Community Association Response

Re: LOC2022-0215

RE: LOC2022-0215

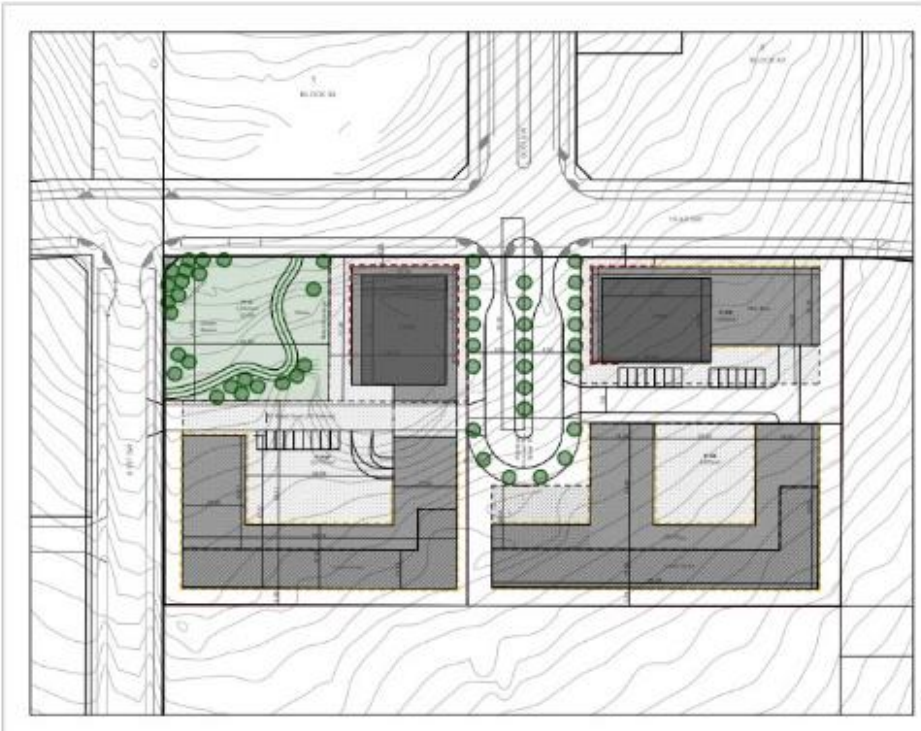
This part of our Community, needs to adhere to the idea of the Liveable Street along 19th Ave SW that encourages access by foot and non-motorized vehicles. The original vision in the ASP, was to limit the retail activation along the south side of the Liveable Street - 19th ave. The applicant has previously challenged this vision with the Orion development, and is again so doing this with this application.

While only at land use the revised plans and MR treatment direction from the city parks department moves the application further from the NAC concept in our opinion.
